3.2 Bloom Street

4.0 Design Changes

4.1 List of Design Changes

4.2 Space planning and compliancy

Bloom Street. North West Elevation

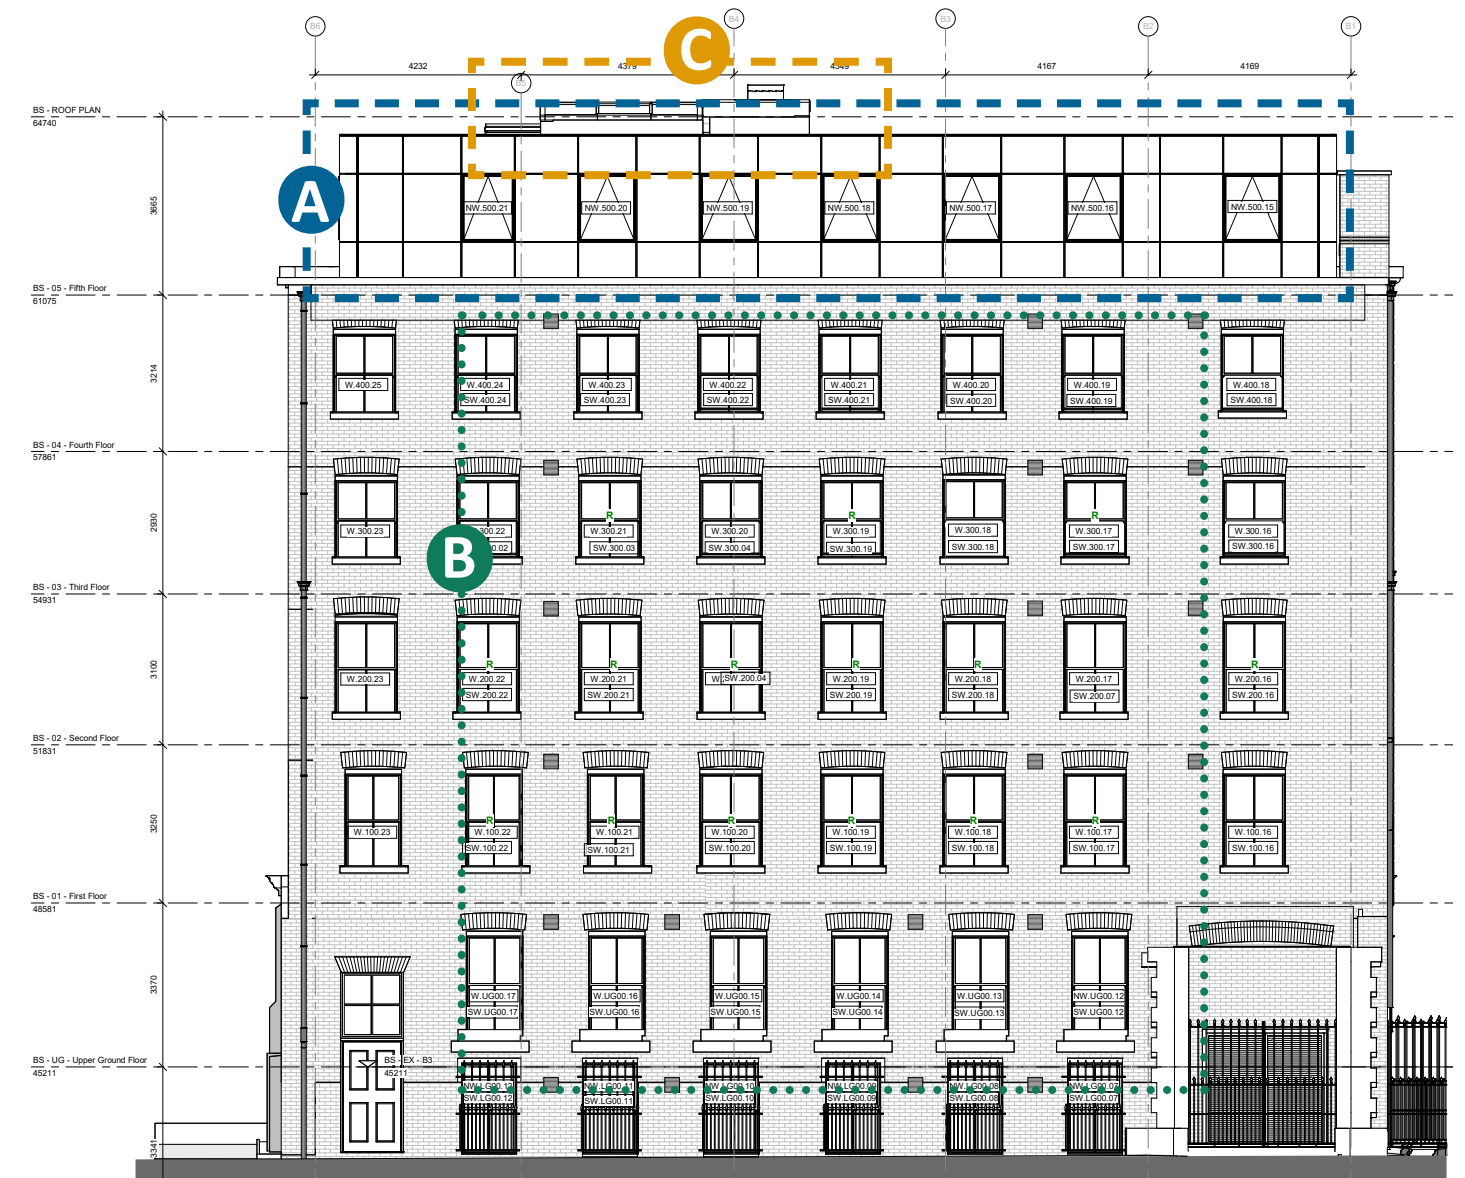
- A** Level 5 extension: Curtain walling system redesigned taking into account the following issues:
- Openable window to be 1100mm above FFL with glazed panel below to have sufficient load bearing properties to prevent people from falling.
 - Continuous louvre fascia above window to supply and extract MHVR system.
 - Vertical glazed fins proposed to be removed. Their function was purely decorative, however their detailing proved to be not robust enough and their location posed an issue for maintenance.

- B** Ground floor curtain walling: Redesigned following changing of function inside from apartment living room to Bin Store. Vertical members are spaced equally, while horizontal members are aligned with existing alleyway gate design. The new gate originally proposed in front of the fixed curtain walling is no longer proposed as it poses an issue in terms of cleaning and maintenance of the area. Bottom panels are of opaque spandrel type while top panels are glazed to allow some natural lights to penetrate inside the bin store. A Blockwall is proposed to be built up to the third horizontal mullion to help adding sturdiness to the facade

- C** Ventilation grills: According to the ventilation strategy, MVHR units require supply and extract duct to penetrate the existing facade. New holes are approx. 200x200mm. It is therefore proposed to introduce 250x250 cast iron ventilation grills, with the design aligned with grills existing on site.
- D** Dry riser Inlet: No longer needed in facade. Strategy has now changed and access to the dry riser will be through the main entrance.
- E** Coverin screen: Amount of plants located to roof significantly reduced due to change of ventilation strategy. Screen no longer required.

Bloom Street. South East Elevation

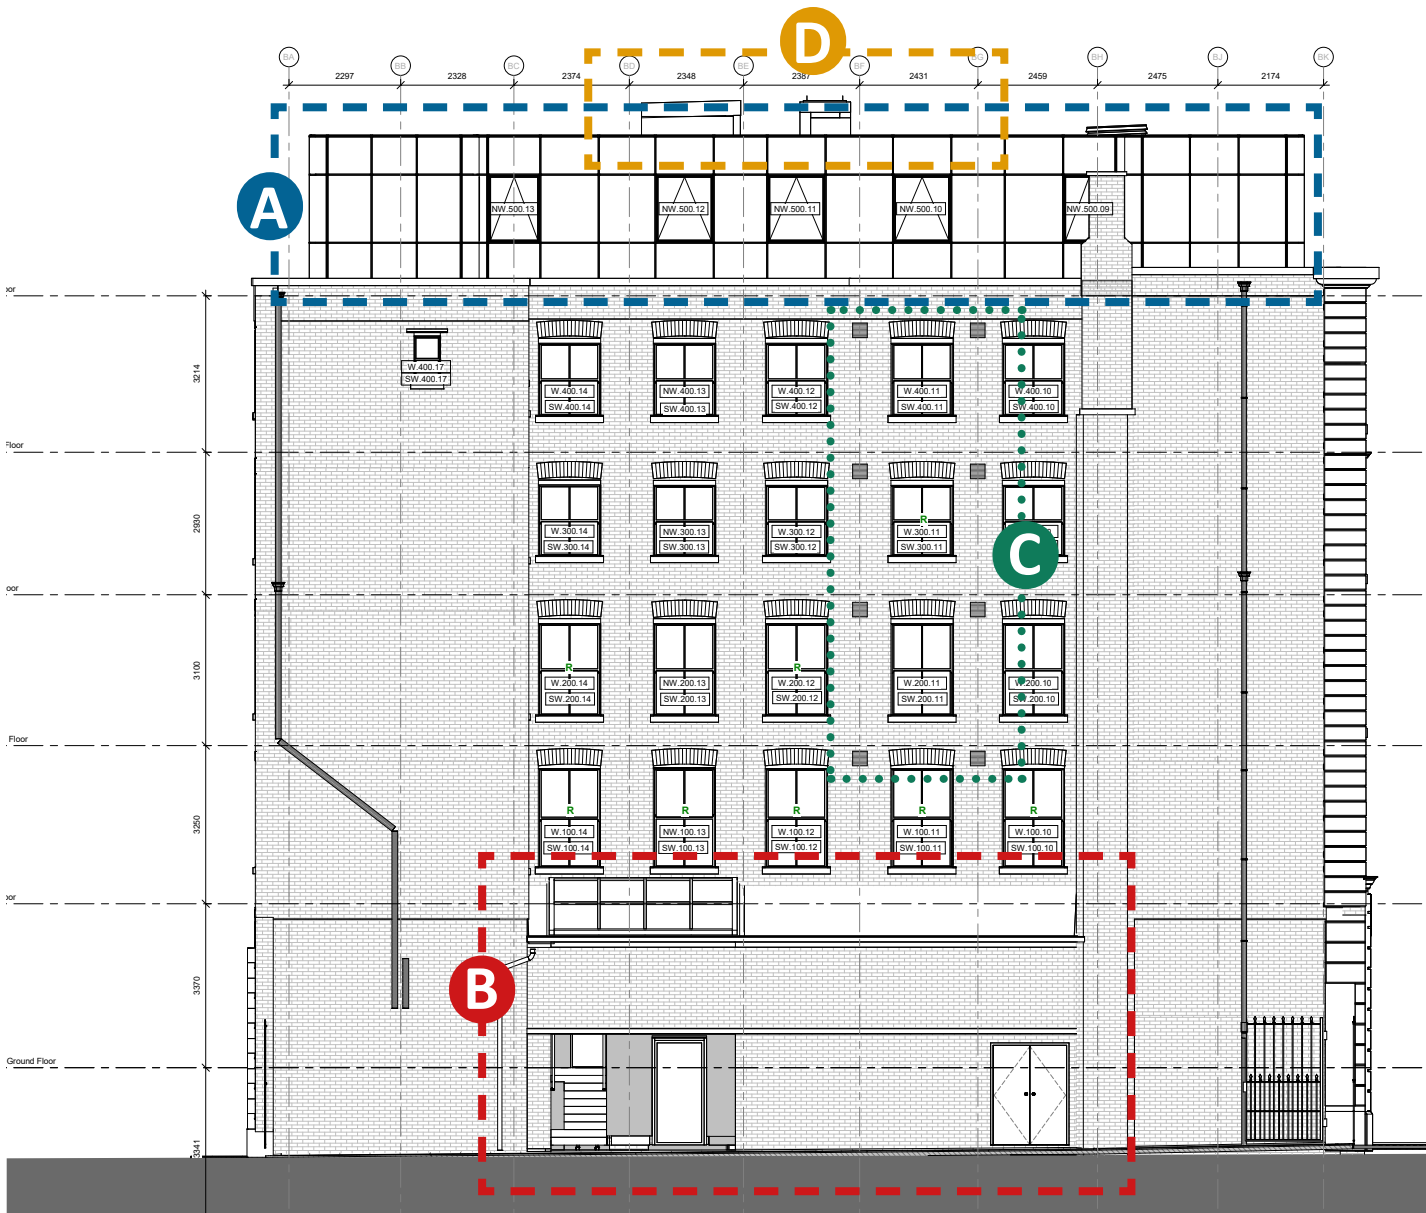
Level 5 extension: Curtain walling system redesigned taking into account the following issues:

- Openable window to be 1100mm above FFL with glazed panel below to have sufficient load bearing properties to prevent people from falling.
- Continuous louvre fascia above window to supply and extract MHVR system.
- Vertical glazed fins proposed to be removed. Their function was purely decorative, however their detailing proved to be not robust enough and their location posed an issue for maintenance.

Ventilation grills:

According to the ventilation strategy, MVHR units require supply and extract duct to penetrate the existing facade. New holes are approx. 200x200mm.

It is therefore proposed to introduce 250x250 cast iron ventilation grills, with the design aligned with grills existing on site.

Coverin screen:

Amount of plants located to roof significantly reduced due to change of ventilation strategy. Screen no longer required.

Bloom Street. North East Elevation

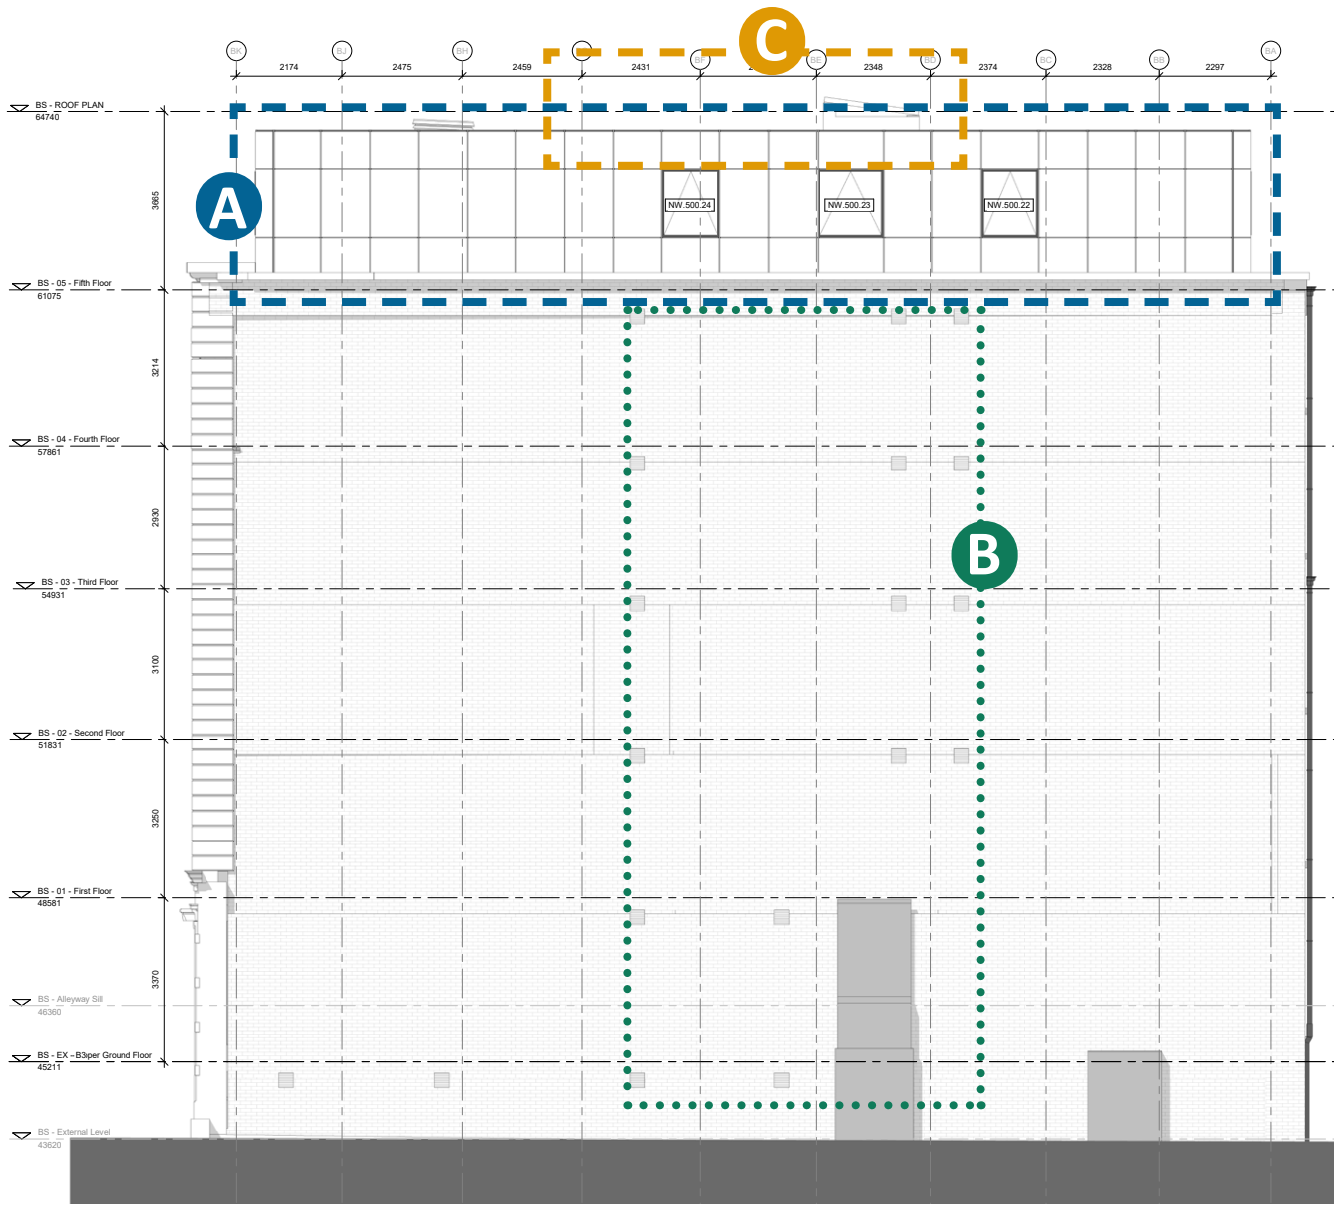
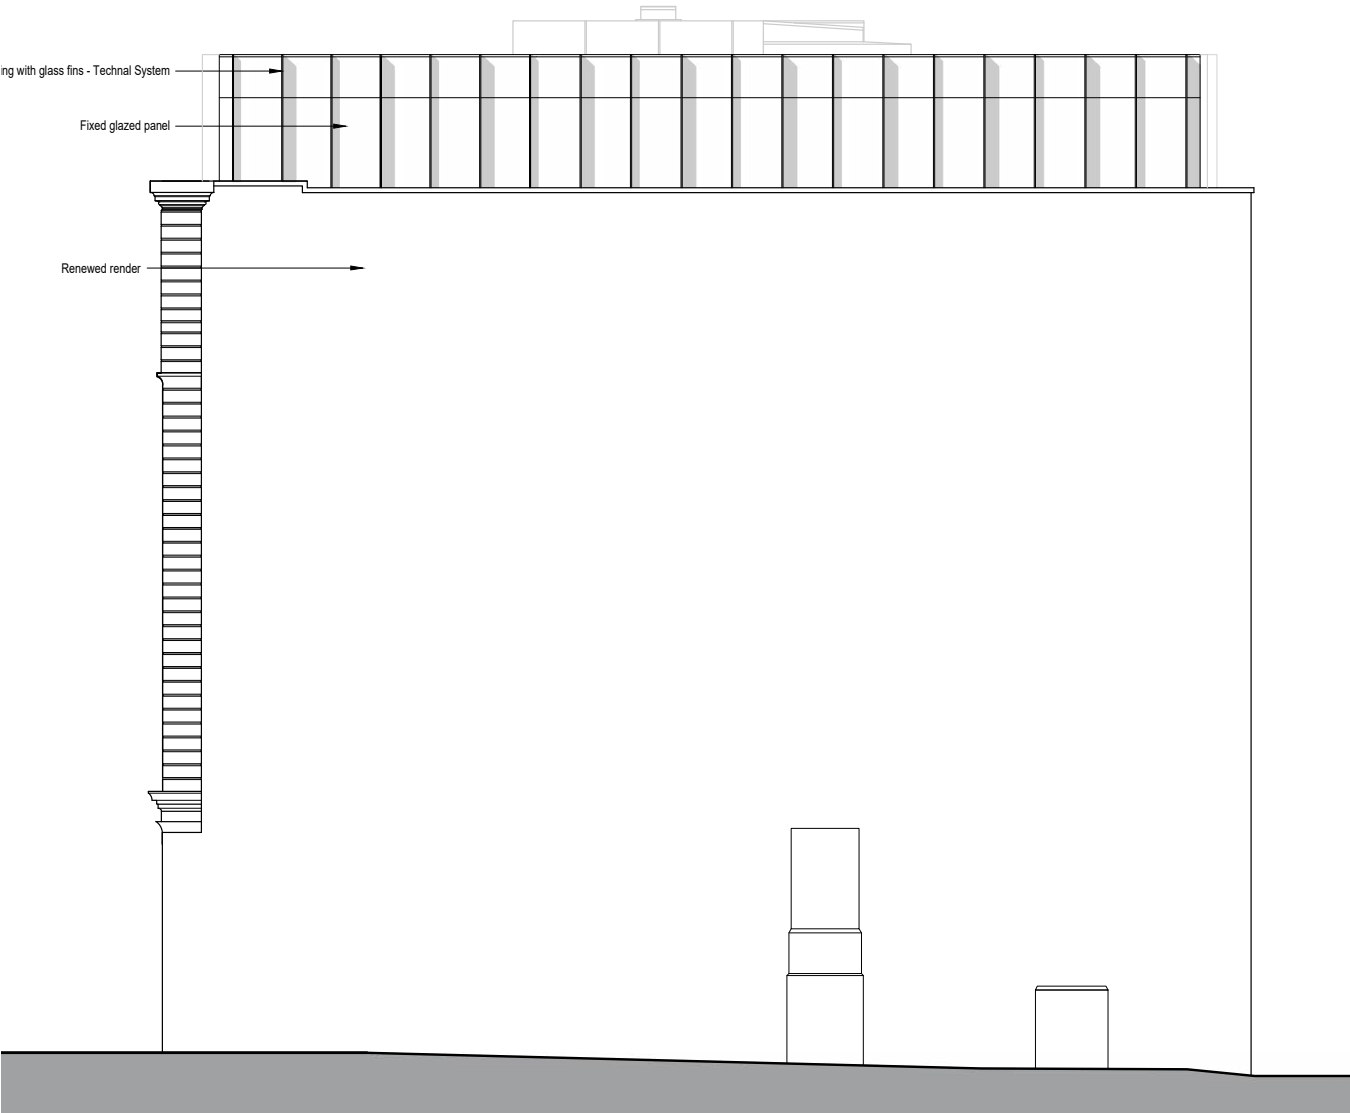
- A** Level 5 extension: Curtain walling system redesigned taking into account the following issues:
- Openable window to be 1100mm above FFL with glazed panel below to have sufficient load bearing properties to prevent people from falling.
 - Continuous louvre fascia above window to supply and extract MHVR system.
 - Vertical glazed fins proposed to be removed. Their function was purely decorative, however their detailing proved to be not robust enough and their location posed an issue for maintenance.

B Alleyway entrance:

C Ventilation grills:
According to the ventilation strategy, MVHR units require supply and extract duct to penetrate the existing facade. New holes are approx. 200x200mm.
It is therefore proposed to introduce 250x250 cast iron ventilation grills, with the design aligned with grills existing on site.

D Coverin screen:
Amount of plants located to roof significantly reduced due to change of ventilation strategy. Screen no longer required.

Bloom Street. Elevations

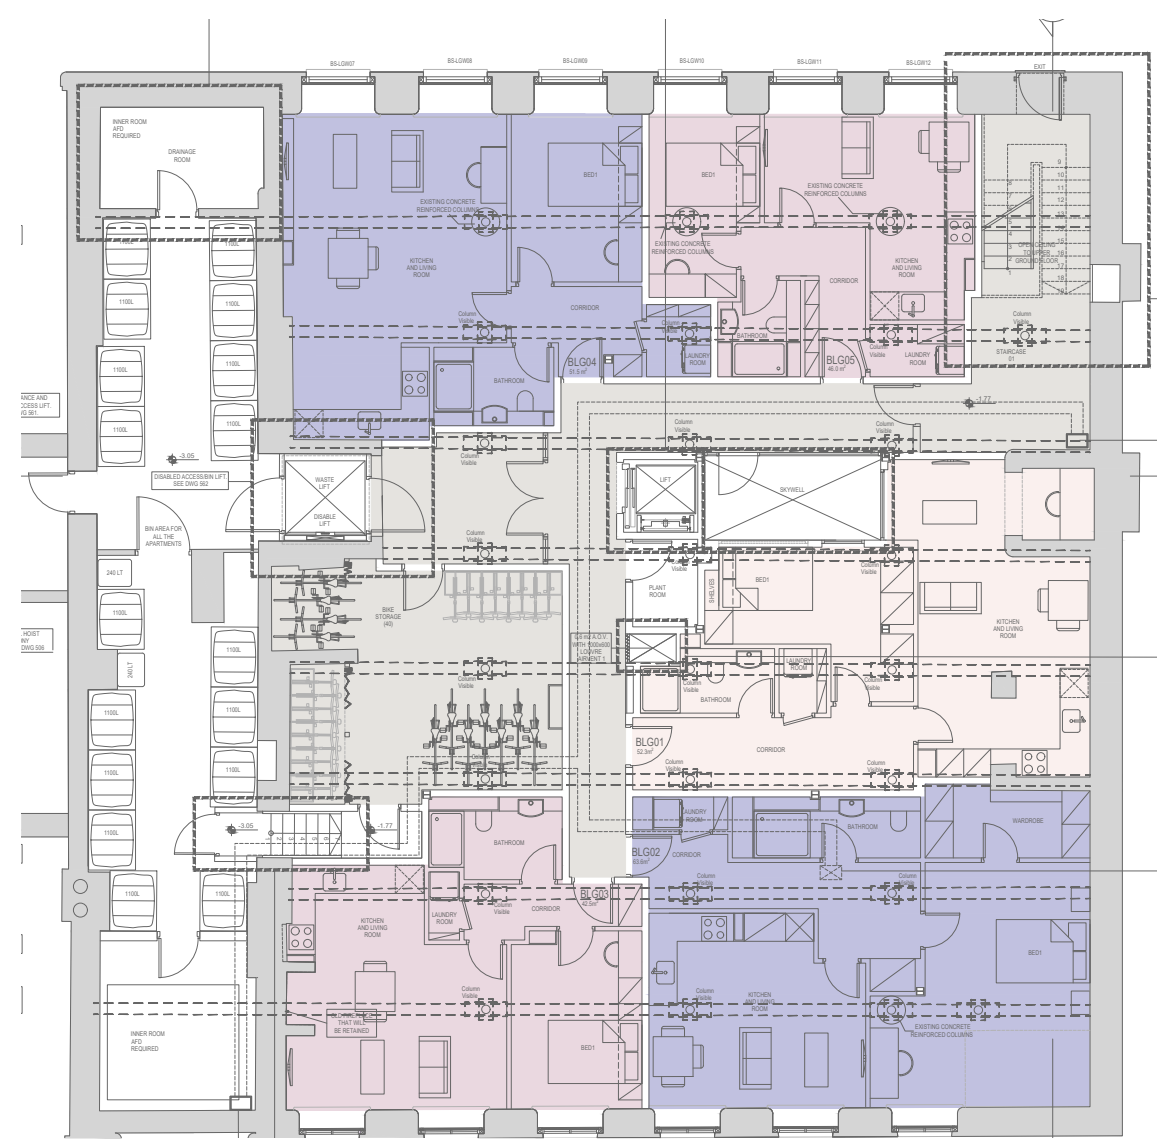
- A** Level 5 extension: Curtain walling system redesigned taking into account the following issues:
- Openable window to be 1100mm above FFL with glazed panel below to have sufficient load bearing properties to prevent people from falling.
 - Continuous louvre fascia above window to supply and extract MHVR system.
 - Vertical glazed fins proposed to be removed. Their function was purely decorative, however their detailing proved to be not robust enough and their location posed an issue for maintenance.

- B** Ventilation grills:
- According to the ventilation strategy, MVHR units require supply and extract duct to penetrate the existing facade. New holes are approx. 200x200mm.
- It is therefore proposed to introduce 250x250 cast iron ventilation grills, with the design aligned with grills existing on site.

- C** Coverin screen:
- Amount of plants located to roof significantly reduced due to change of ventilation strategy. Screen no longer required.
